AR 22-0008 Alden Apartments

AR 22-0008 Alden Apartments

Parking Standards (TDC 73C)

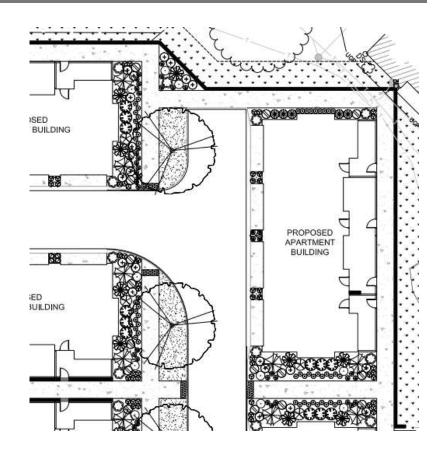
- Minimum parking requirements (361 required* & 442 provided)
- Bike parking
 (45 units, bicycle parking within each units garages)
- Parking / drive aisle standards
- Parking lot landscaping
- 8 carports are proposed for the existing parking lot
